CONSERVATION TEAM CONSULTATION APPLICATION RESPONSE

APPLICATION REF:	26/01568/FPH & 26/01569/LBC
CASE OFFICER:	VW
APPLICATION SITE:	Panna Cottage, Pudding Lane, Barley, Royston, Hertfordshire, SG8 8JU
DESCRIPTION OF WORKS:	Erection of rear conservatory following removal of existing rear window. Demolish outside garden wall between lower and upper terrace, remove paving slabs from lower terrace, set aside to re-use. Installation of 2.no EV charging points to existing garage. Erection of rear conservatory following removal of existing rear window.

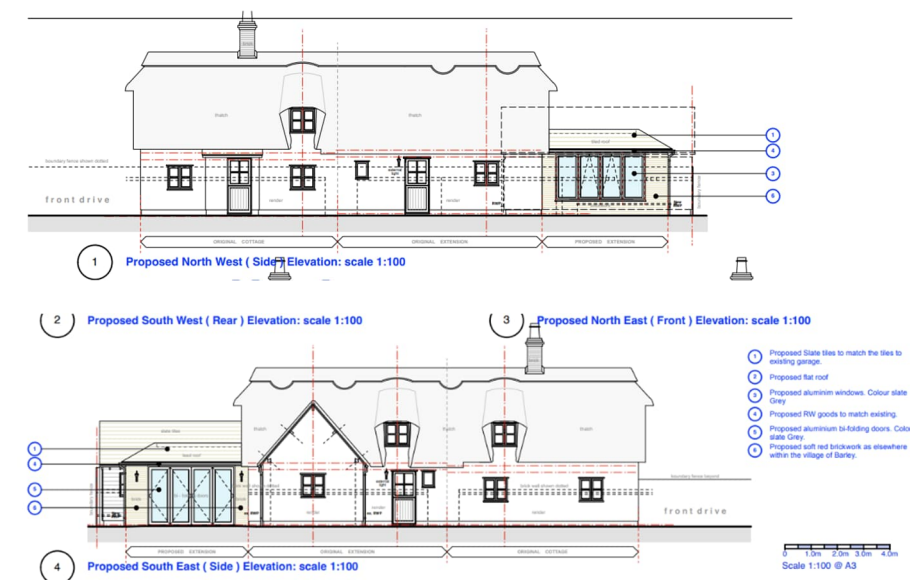
My only slight concern is the extension's fenestration. In my opinion, the north-west elevation is acceptable although there is a clear difference between these windows and those on the host building and whilst I am prepared to accept the 4no. bi-folding doors to the south-east elevation, my opinion, is that the pre-app fenestration (pair of doors with glazing above a plinth on either side) is a better detail.
